Re: Plan Modification – Filling Plan, Gas Extraction System Layout, and Beneficial Use Soils
Acceptance Criteria
Brown County South Landfill – License No. 3565

**Plan of Operation Modification Request of the
Filling Plan, Gas Extraction System Layout, and Beneficial Use Soils
Acceptance Criteria
Brown County South Landfill
WDNR Landfill License No. 3565**

LANDFILL GAS EXTRACTION SKID AND FLARE INSTALLATION

FIGURE 1
PHASE 1 TOP OF WASTE GRADES
FILL SEQUENCE 1

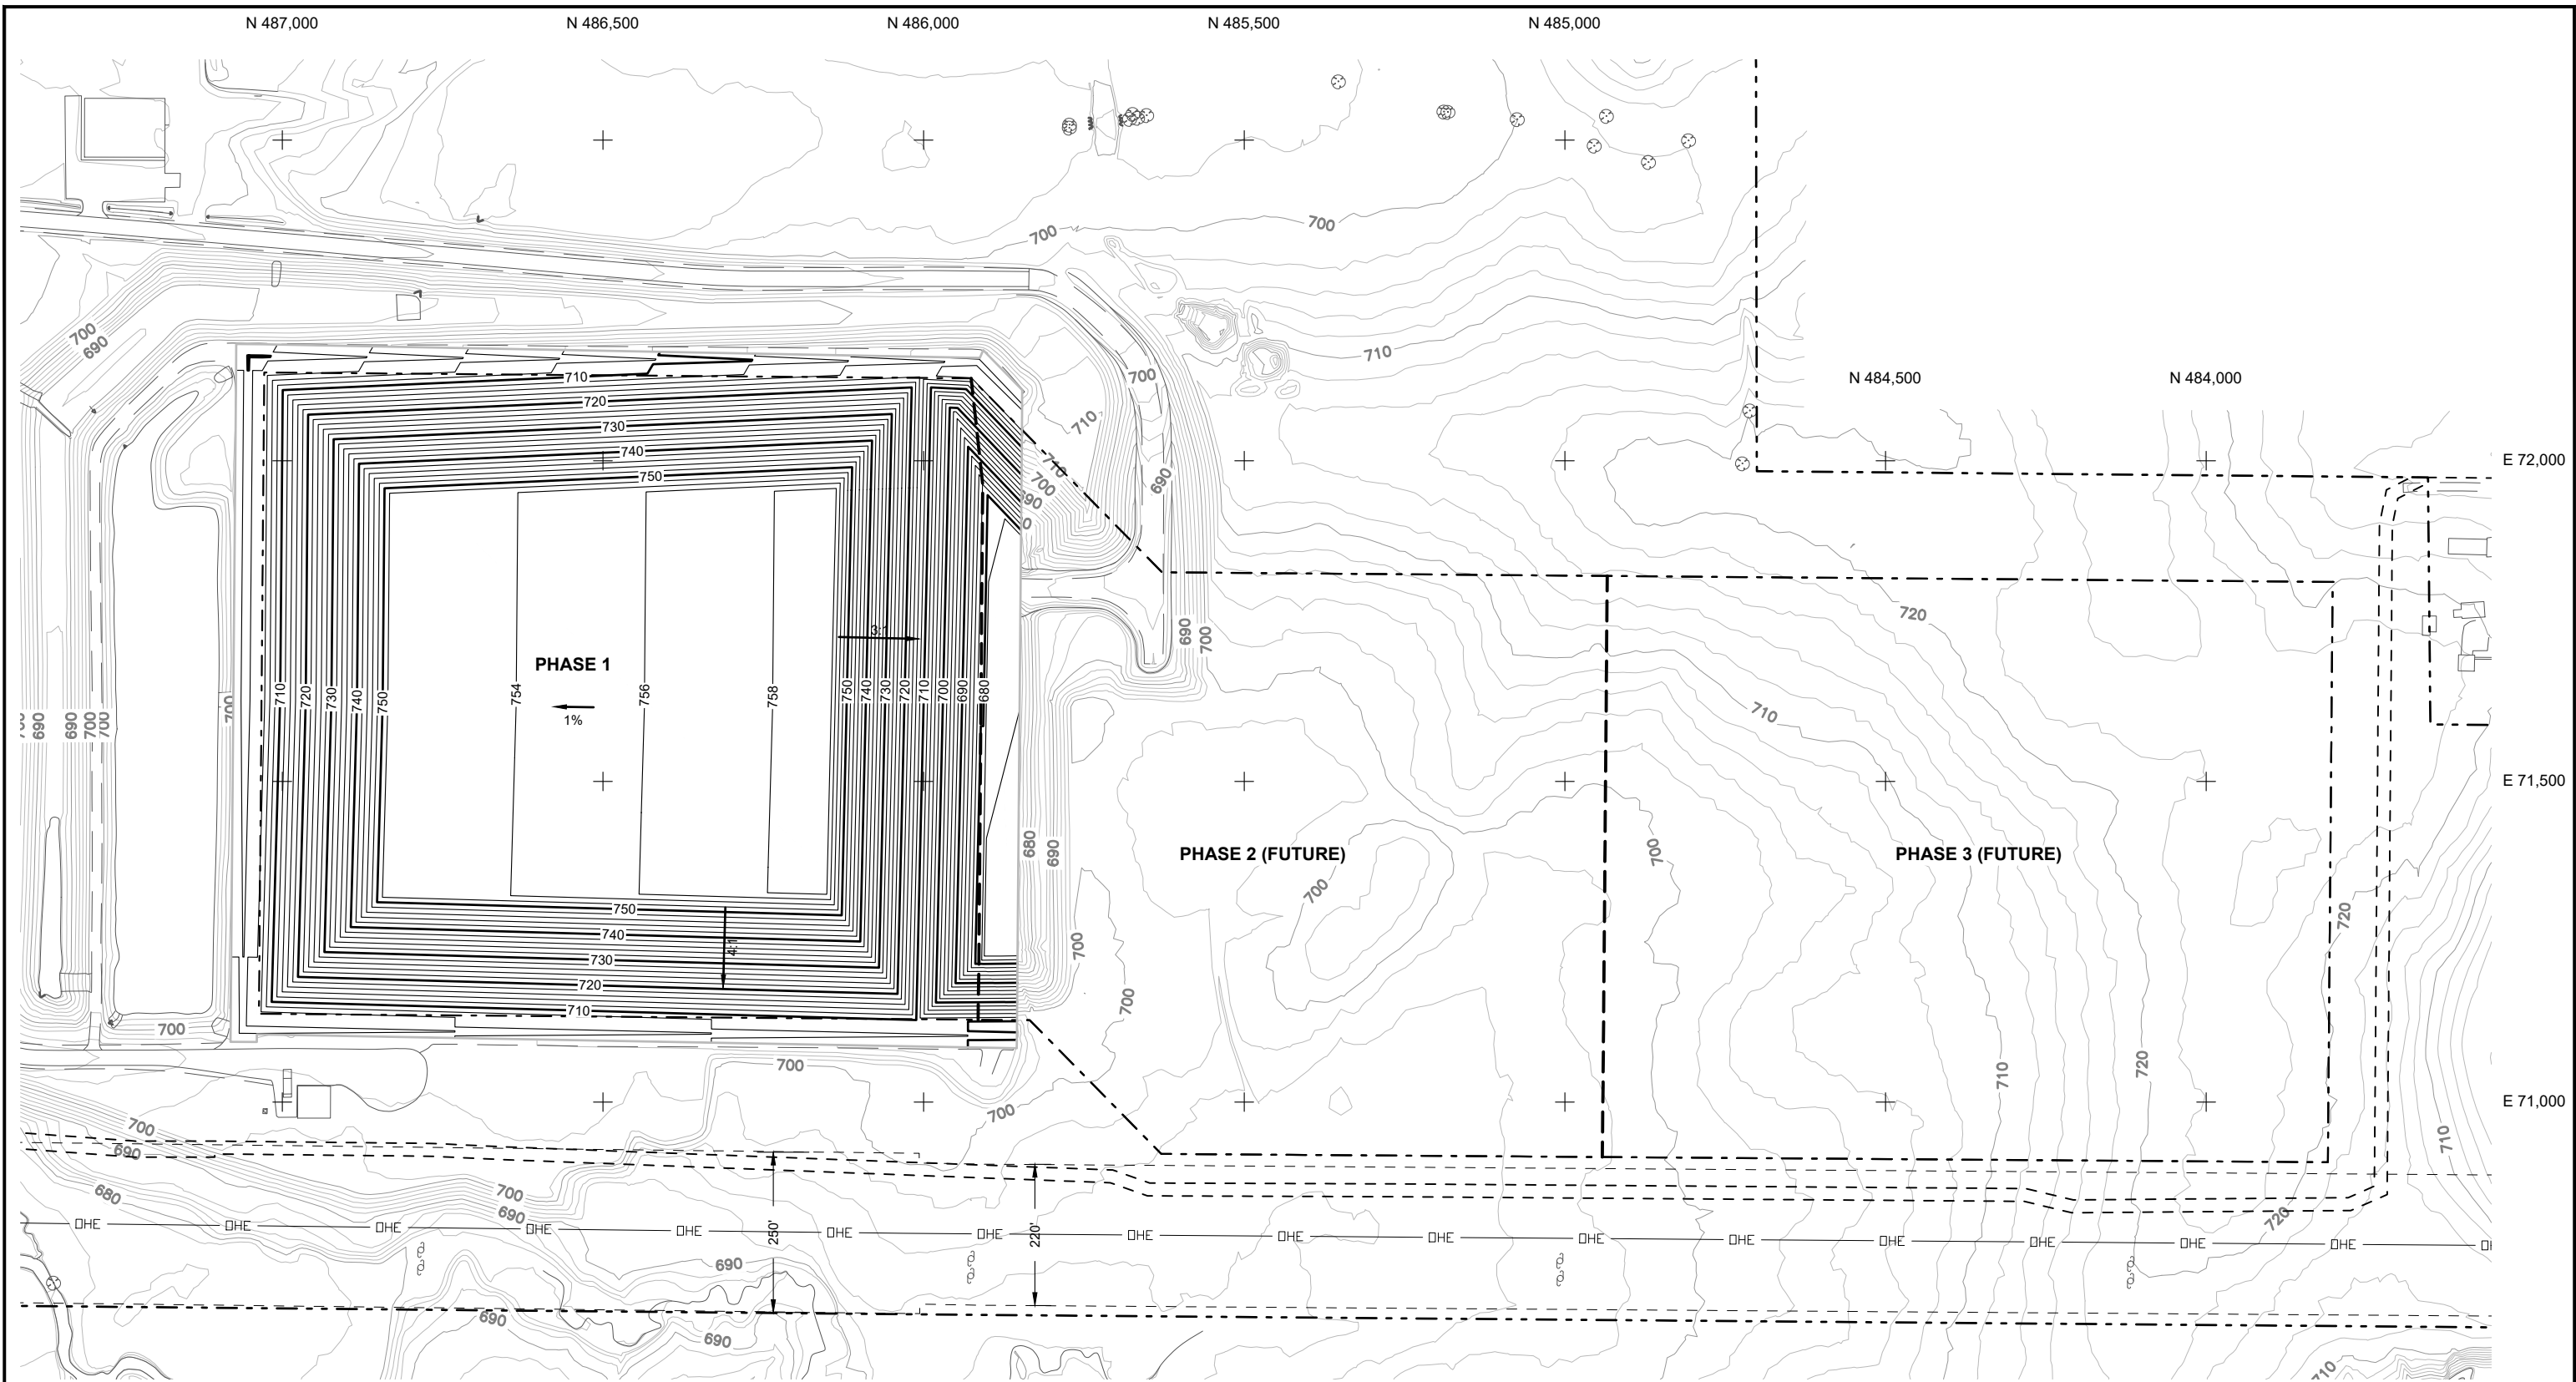
Figure 1 shows the planned Phase 1 fill grades to approximately 758 feet mean sea level (msl). Figure 2 shows additional filling (referred to as Fill Sequence 1A) within Phase 1 footprint in accordance with permitted top of waste grades up to 793 feet msl. The additional 35 feet of fill is approximately 369,000 cubic yards (cy) of capacity (Figure 3). Figures 4 through 6 show the previously approved filling plan through Phase 2 and Phase 3 construction. The last fill sequence will be over Phases 1 through 3 and are decreased by the same volume as the additional fill over Phase 1. The total available airspace capacity remains at 9,303,000 cy.

FIGURE 2

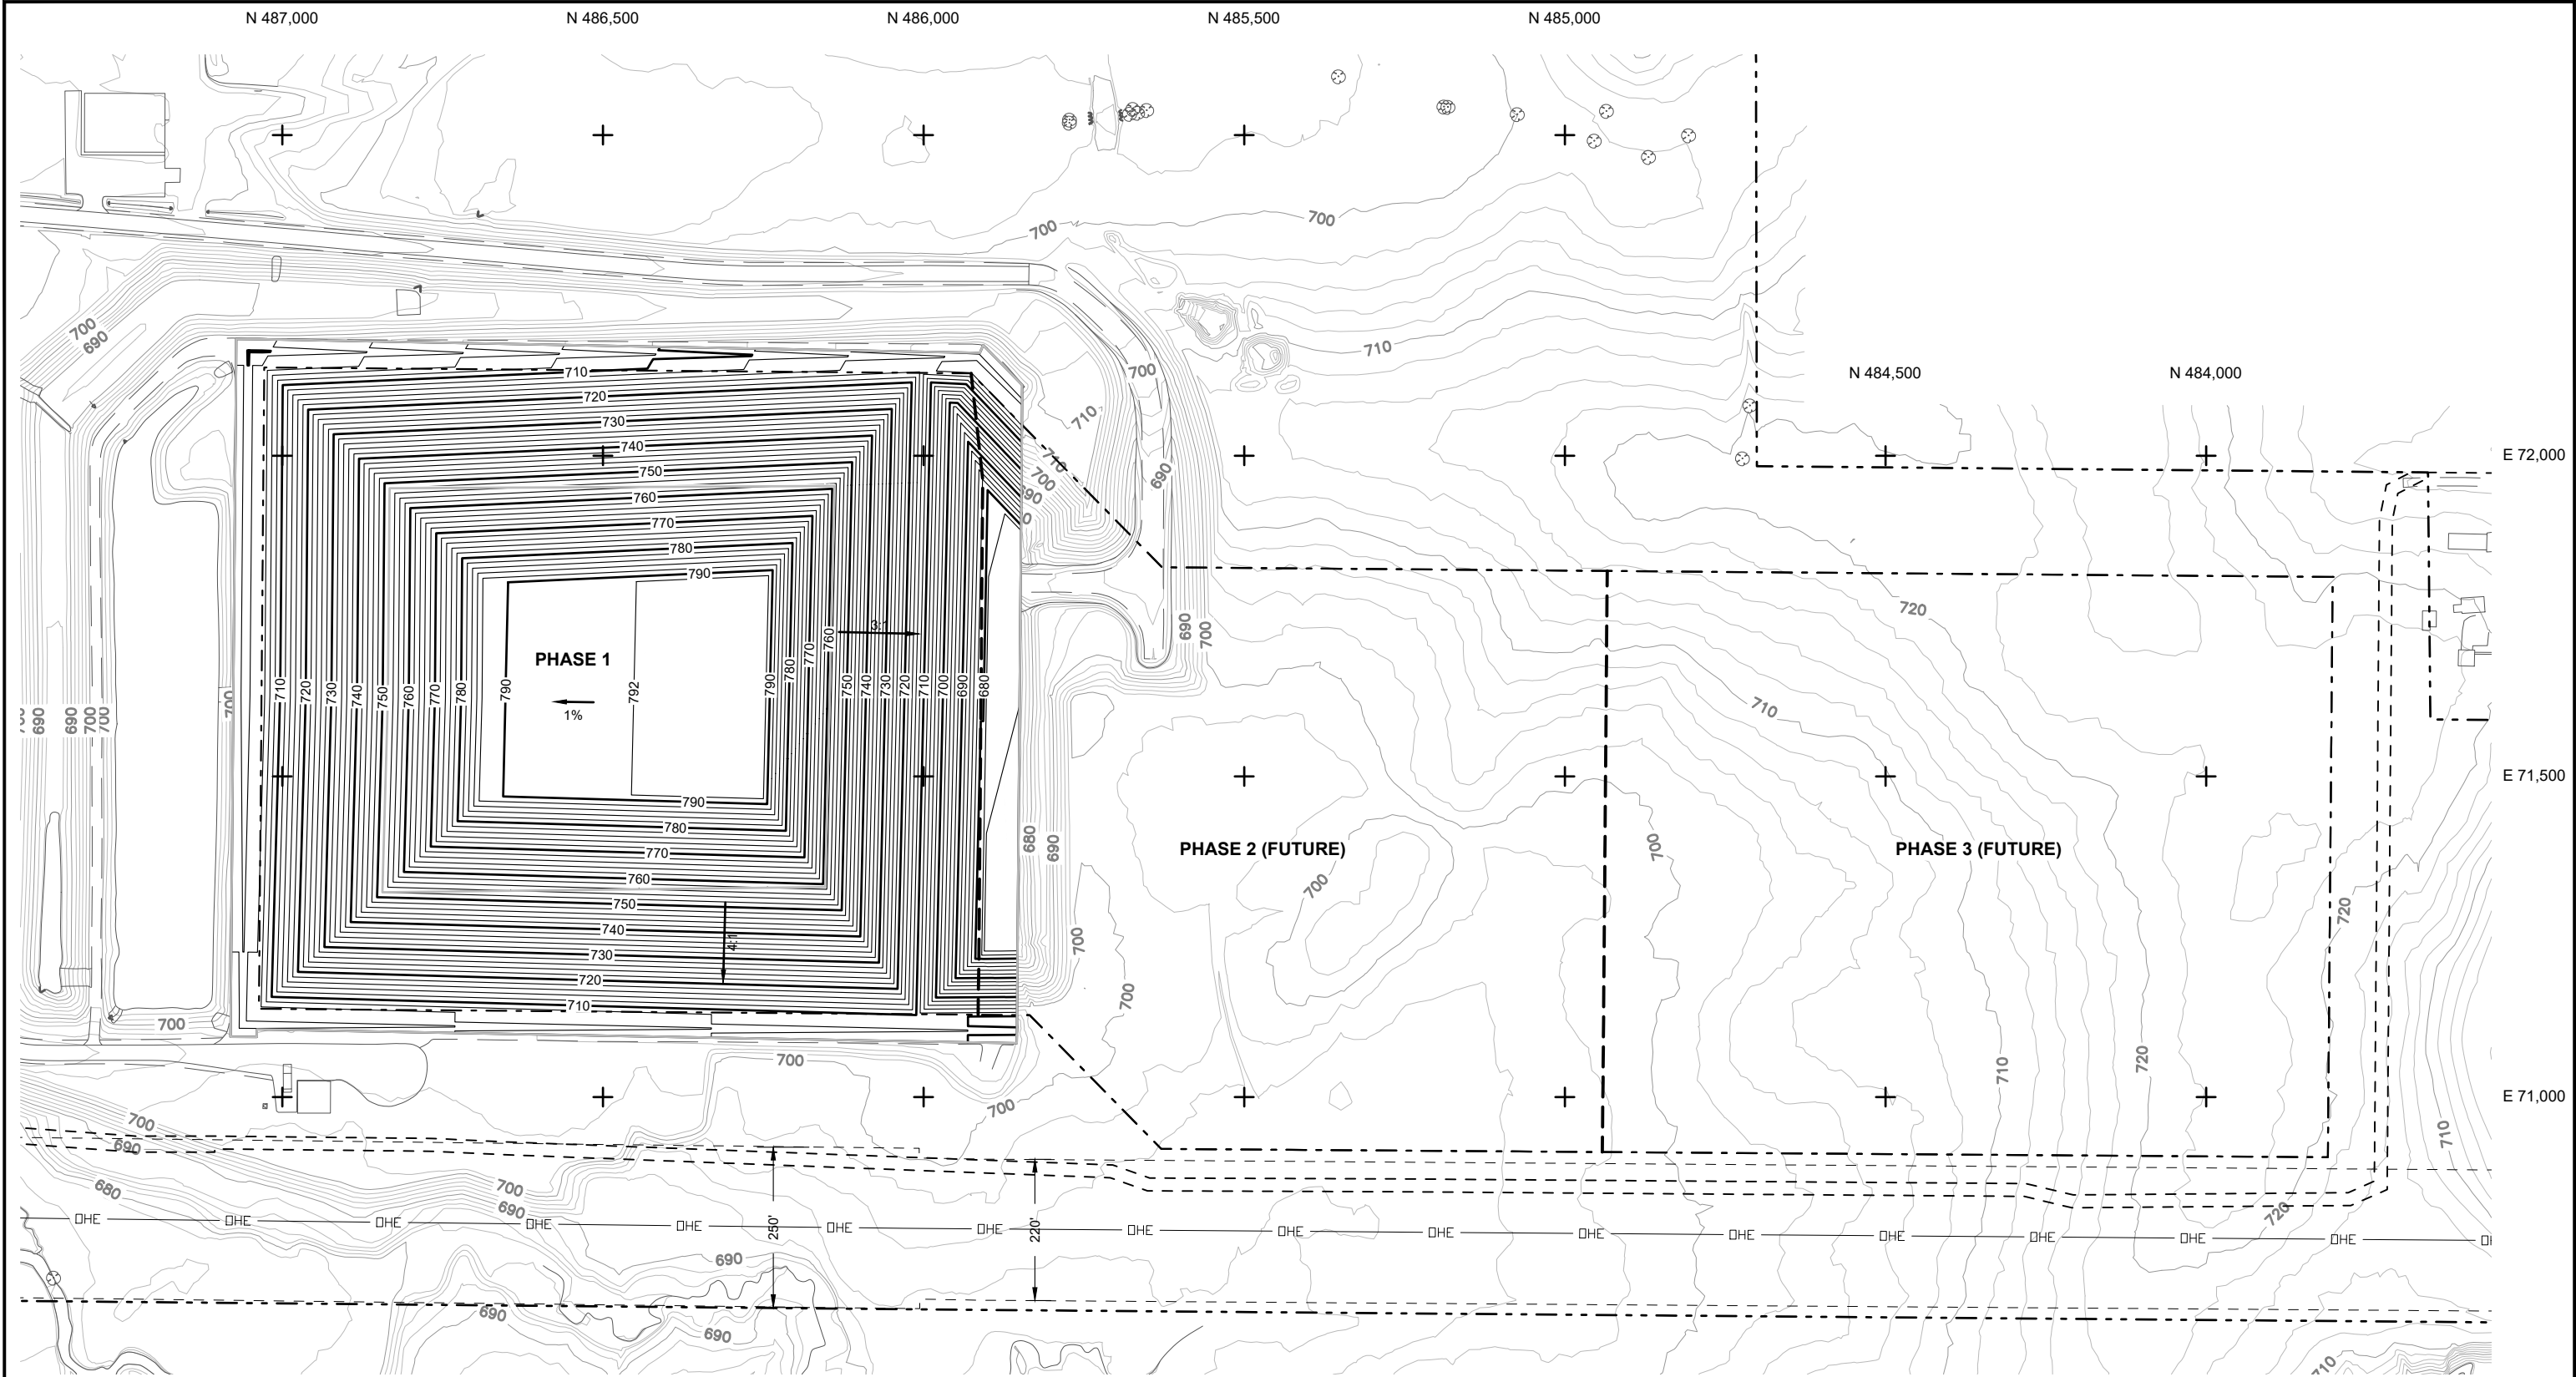
- NOTES:**
- 1) APPROVED TOP OF WASTE GRADES PER PLAN OF OPERATION.
 - 2) PHASE 1 LIFT SEQUENCE 1A PROPOSED TO ELEVATION 792.

BROWN COUNTY SOUTH LANDFILL		
FIGURE 3 PHASE 1 TOP OF WASTE GRADES FILL SEQUENCE 1A - 369,000 CY		
Date Completed: JANUARY 2025	Revision Date:	
Drawn By: DJM4	Checked By: SMB	Project No: 25B027

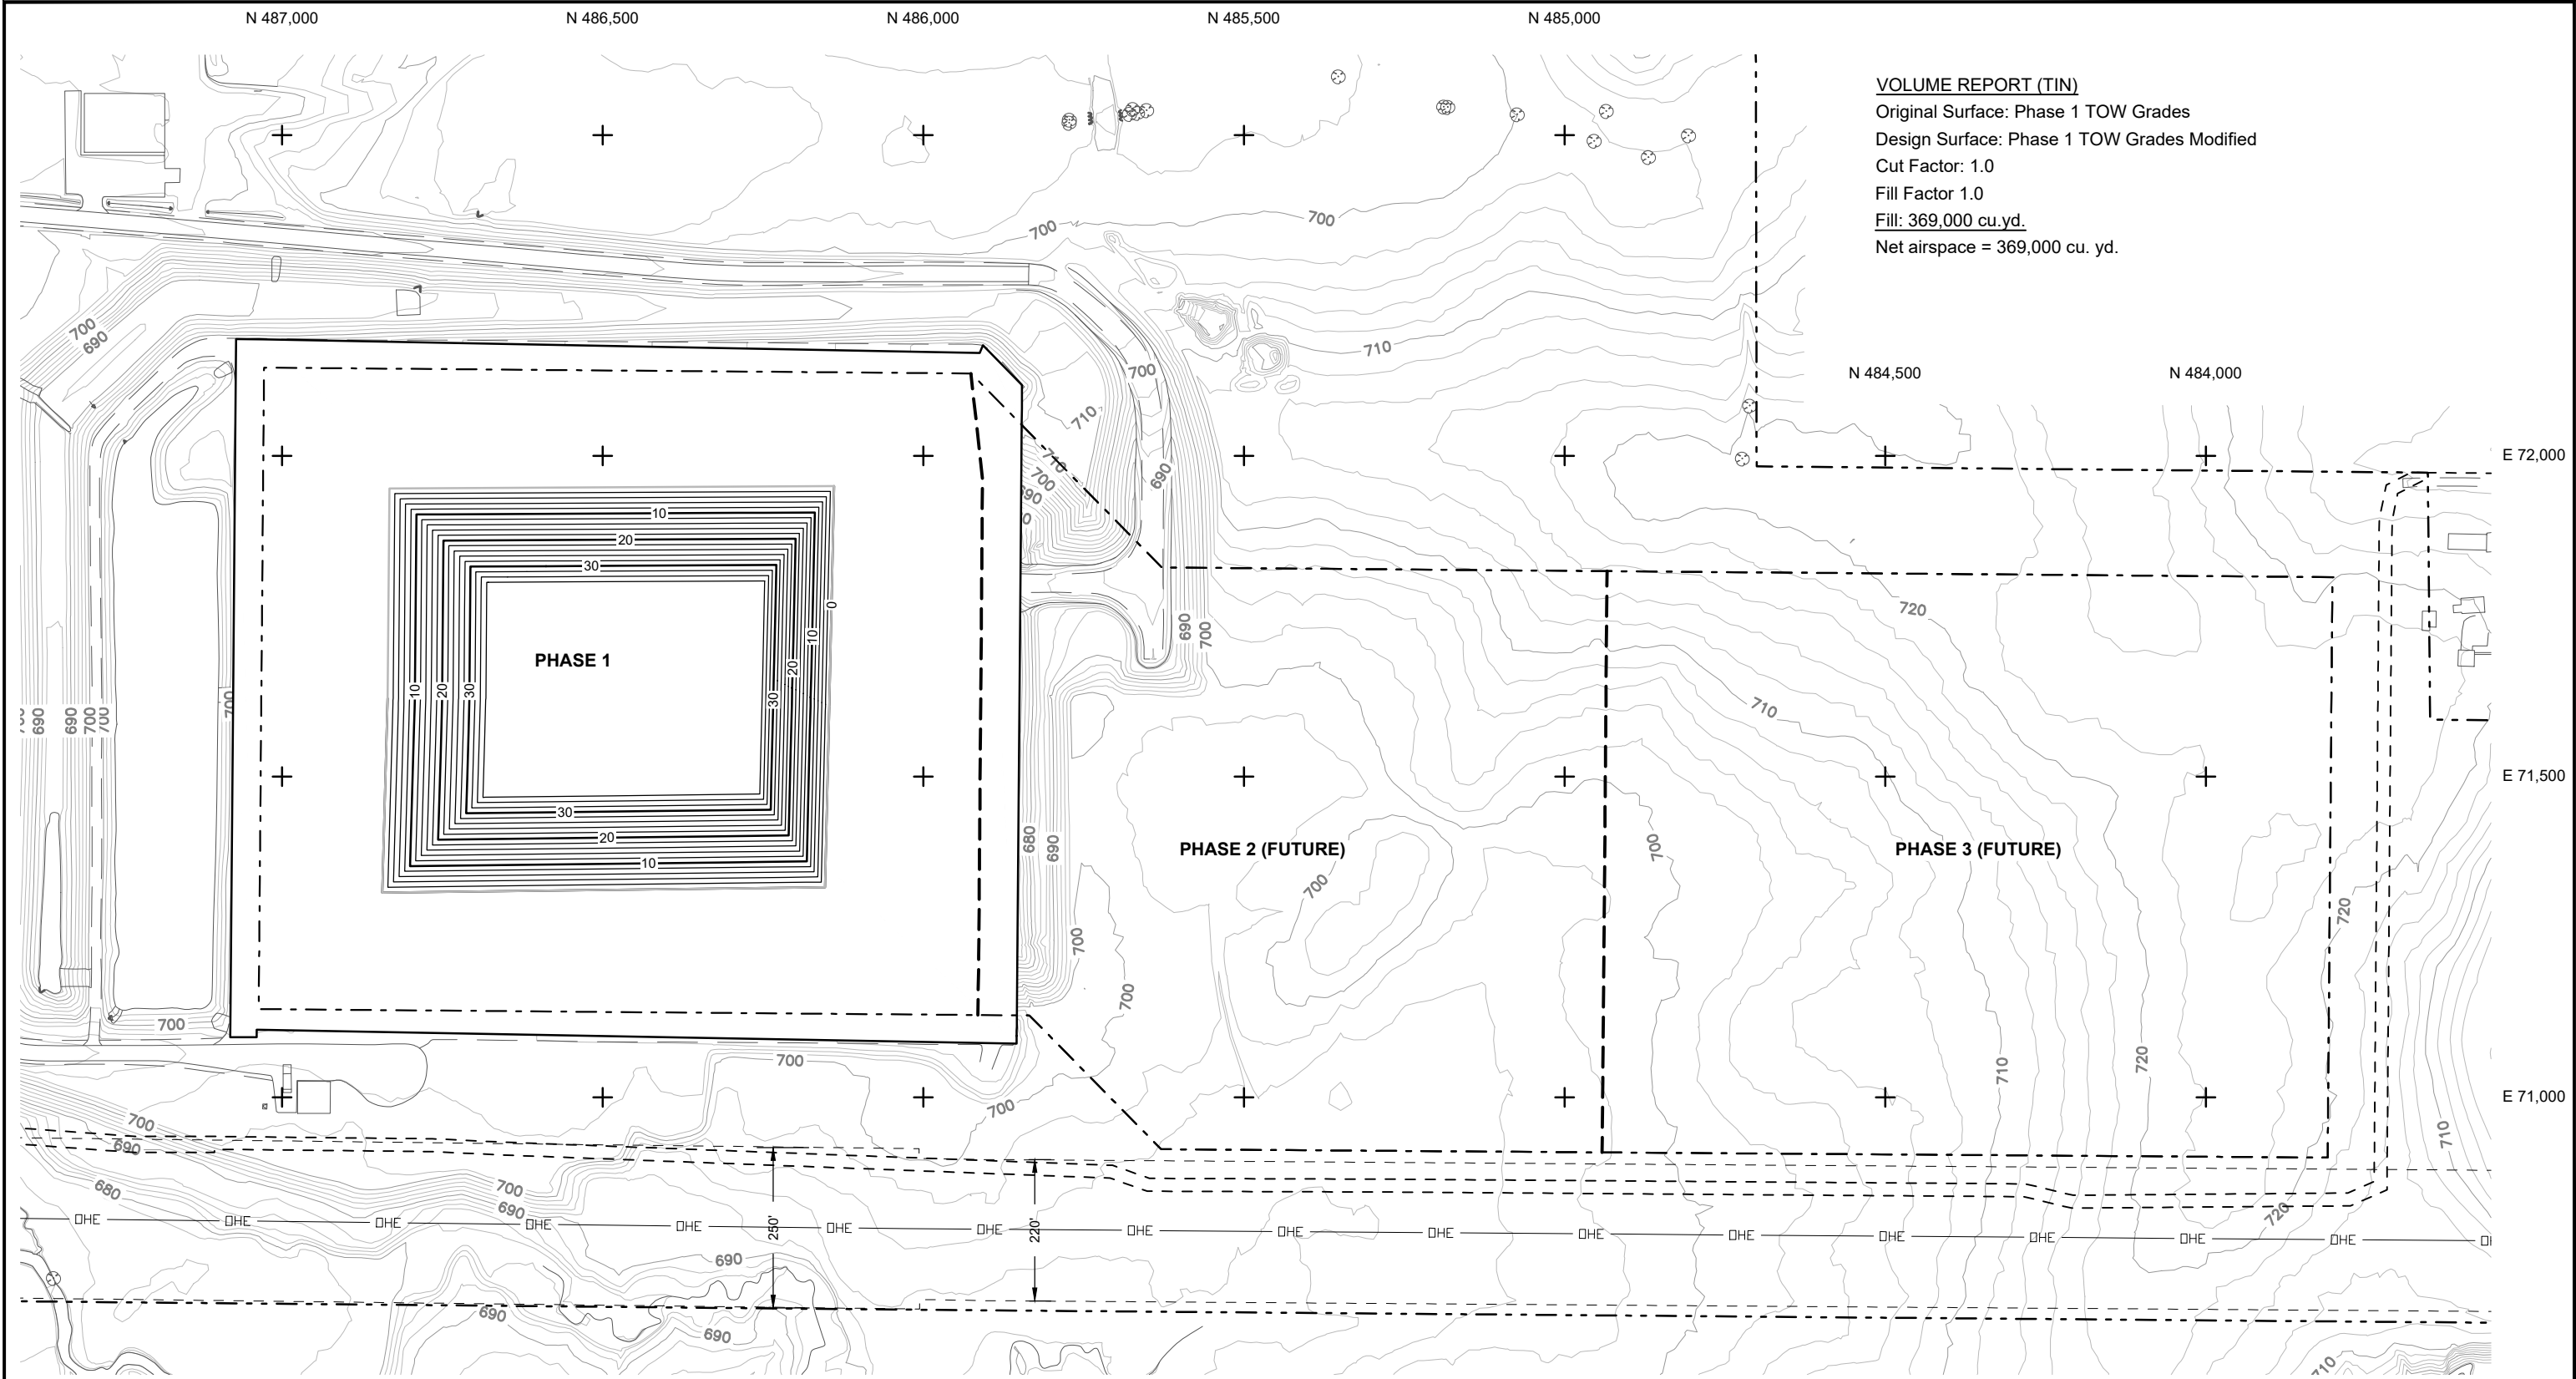
- NOTES:**
- 1) APPROVED TOP OF WASTE GRADES PER PLAN OF OPERATION.
 - 2) CONTOURS WITHIN THE LIMITS OF WASTE REPRESENT THE DIFFERENCE IN FEET BETWEEN THE PROPOSED TOP OF FILL SEQUENCE 1 AND 1A (369,000 CY).

⁽⁴⁾ Phase 1A Airspace Capacity includes 369,000 cubic yards of filling within Phase 1 footprint.
